From: Anita Gardner <Anita.Gardner@arun.gov.uk>
Sent: 21 July 2020 08:10
To: Planning.Responses <Planning.Responses@arun.gov.uk>
Subject: FW: CM/64/19/PL

From: Martin Gillam [REDACTED]
Sent: 19 July 2020 12:06
To: Anita Gardner <Anita.Gardner@arun.gov.uk>
Subject: CM/64/19/PL

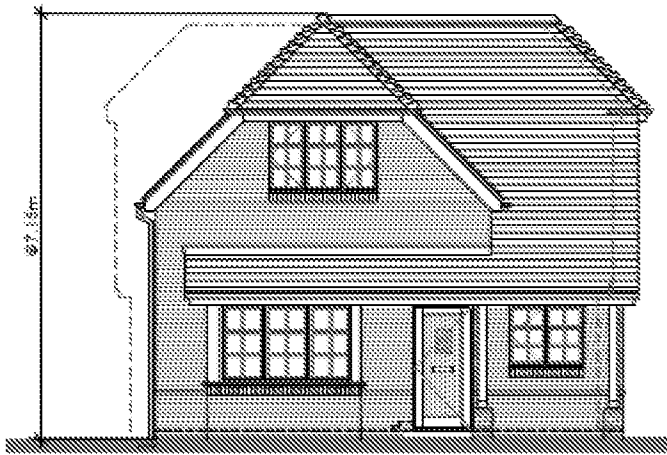
Now that the architect has included some measurements it is clear that the location of the house is too close to mine and not conforming with Council planning guidelines – see below.

The applicant has stated that they need to locate the house 7.3m from my property to enable car parking at the front of the house, so not only does the design and location have to change but also parking arrangements. Consequently planning for Plot 8 should be revoked.
